Analyses of Groundwater Flow, Contaminant Fate and Transport, and Distribution of Drinking Water at Tarawa Terrace and Vicinity, **U.S. Marine Corps Base Camp Lejeune, North Carolina: Historical Reconstruction and Present-Day Conditions**

Response to the Department of the Navy's Letter on: **Assessment of ATSDR Water Modeling for Tarawa Terrace**

RESPONSE TO THE DEPARTMENT OF THE NAVY'S LETTER ON ASSESSMENT OF ATSDR WATER MODELING FOR TARAWA TERRACE

ATTACHMENT 6: OBSERVED AND SIMULATED WATER LEVELS, MODEL LAYER 1, AND CALIBRATION TARGETS FOR (A) PREDEVELOPMENT (STEADY STATE) CONDITIONS AND (B) TRANSIENT CONDITIONS, 1951–1994, TARAWA TERRACE AND VICINITY, U.S. MARINE CORPS BASE CAMP LEJEUNE, NORTH CAROLINA (FROM MASLIA ET AL. 2007B, FIGURE A10)

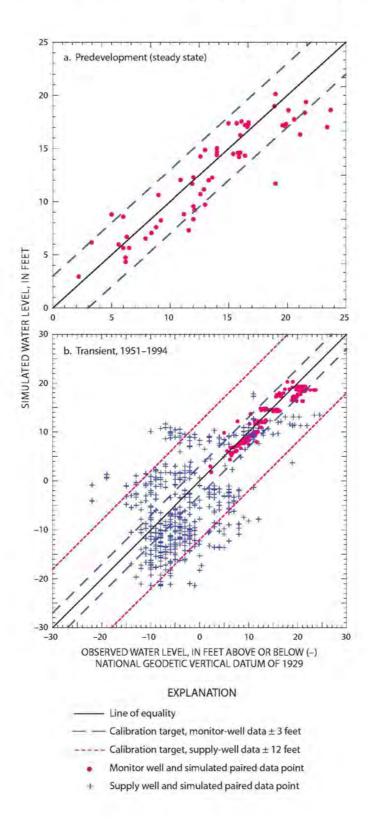
For Tarawa Terrace groundwater, the difference between observed and simulated elevations is 5 to 10 feet at many times during the 1970's and 1980's. This is a significant disparity because the total change in groundwater elevation from the source area to the receptor wells is approximately 10 to 12 feet.

This DON approach to evaluating model calibration applies a generalized "rule of thumb" to the Tarawa Terrace groundwater-flow models and is possibly based on wording found in ASTM Guide D5981-96, Standard Guide for Calibrating a Ground-Water Flow Model Application, (ASTM 1996, section 6.4.1): "the acceptable residual should be a small fraction of the difference between the highest and lowest heads across the site." ATSDR is not in agreement with this approach to evaluate model calibration. A careful review of ASTM D5981-96 in its entirety indicates that the DON's comment, as stated, is totally removed from the context of Section 6 of the ASTM Standard Guide as well as the context of the accuracy of field data used to calibrate the Tarawa Terrace groundwater-flow model, as described in the Chapter C report (Faye and Valenzuela 2007). For example, in Section 6.4, ASTM D5981-96 states: "the magnitude of the acceptable residual depends partly upon the magnitude of the error of the measurement or the estimate of the calibration target and partly upon the degree of accuracy and precision required of the model's prediction." Furthermore, Note 2 of ASTM D5981-96 states: "Acceptable residuals may differ for different hydraulic head calibration targets within a particular model. This may be due to different errors in measurement." The Tarawa Terrace Chapter C report (Faye and Valenzuela 2007, p. C24) provides a comprehensive discussion of water-level measurement errors arising from the use of airlines and pressure gages to measure water levels. Fave and Valenzuela also point out that this is consistent with the discussions of LeGrand (1959) who described problems associated with the use of airlines to measure water levels at Camp Lejeune as far back as 1959. As pointed out in Faye and Valenzuela (2007, p. C24): "Typically, reported water levels [at supply wells] vary in excess of 20 ft during the period of measurement, and frequently 10 ft or more from month to month.... Such variability also may indicate leaking or damaged airlines or pressure gages."

Faye and Valenzuela (2007, p. C24) also provide detailed discussions as to the rationale for selecting two calibration target ranges for the transient groundwater-flow model. At wells where water-level measurements were obtained using airlines and pressure gages, the calibration target was selected as an absolute difference of 12 ft between simulated and measured water levels. This target was based on well-known disadvantages of using pressure gages and airlines to obtain accurate water-level measurements. Where water-level measurements were obtained using the more highly accurate tapes and similar devices at monitor wells, the calibration target was selected as an absolute difference of 3 ft between simulated and measured water levels. This target was based on the least accurate of these water-level measurements where topographic maps were used to estimate the altitude of a measuring point.

Evaluating model calibration using the "rule of thumb," as the DON has suggested, also assumes that no other information is available to determine calibration targets. When information is available, such as direct knowledge of methods of water-level measurements and information characterizing the measurement device(s), the calibration targets should be based on these data, not on a "rule of thumb." Faye and Valenzuela (2007) provide detailed listings of measured water levels in supply and monitor wells throughout Tarawa Terrace (Appendix C5).

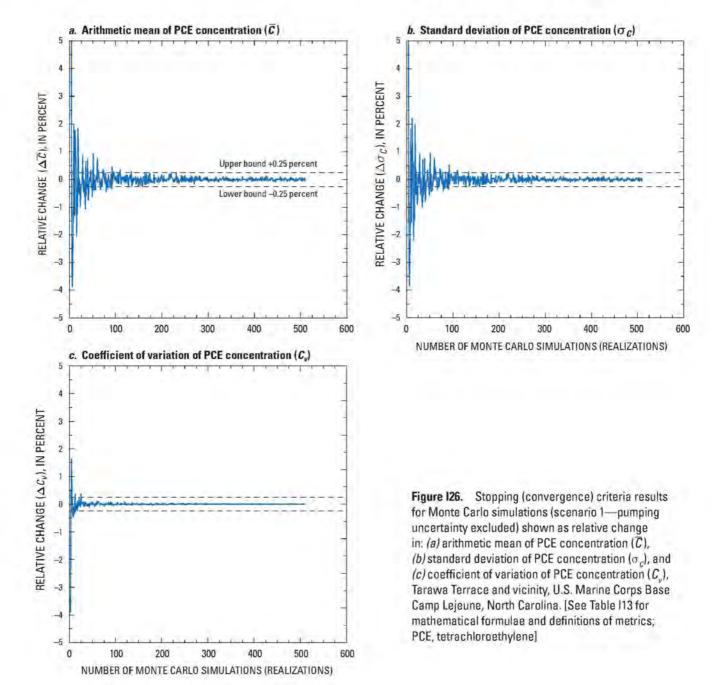
The issue that should be addressed is not how many realizations produced physically plausible

solutions, but rather, are the 510 realizations that were successfully produced sufficient to represent an infinite number of random solutions? The metric that determines whether or not this question is answered in the affirmative is the relative change in stopping criteria between successive model simulations. If this relative change is small within a predetermined range, then additional simulations are redundant and do not statistically contribute to an improvement of the representativeness of the overall results with respect to the statistical distributions. The Chapter I report (Maslia et al. 2009) describes in detail the criteria used to determine when a sufficient number of realizations have been achieved. Three stopping criteria were used to halt the Monte Carlo simulation: (1) relative change in the arithmetic mean of PCE concentration in finished water at the Tarawa Terrace WTP, $\Delta \overline{C}$; (2) relative change in the standard deviation of PCE concentration in finished water at the Tarawa Terrace WTP, $\Delta \sigma_c$; and (3) relative change in the coefficient of variation of PCE concentration in finished water at the Tarawa Terrace WTP, $\Delta C_{\rm w}$. Mathematical formulae and definitions of the aforementioned stopping criteria metrics are listed in Table I13 of the Chapter I report (Maslia et al. 2009). In applying the stopping criteria to the Monte Carlo simulations, an upper and lower bound of $\pm 0.25\%$ was used for each metric. When the computed relative change $(\Delta \overline{C}, \Delta \sigma_C, \text{ and } \Delta C_v)$ was within the aforementioned bounds and the total number of realizations was 500 or more, the Monte Carlo simulation process was halted. Examples of the stopping criteria for each metric are shown graphically in Attachment 8 (Maslia et al. 2009, Figure I26). As can be seen from the stopping criteria, insignificant change (much less than 2.5%) occurs after 300 realizations. Therefore, 510
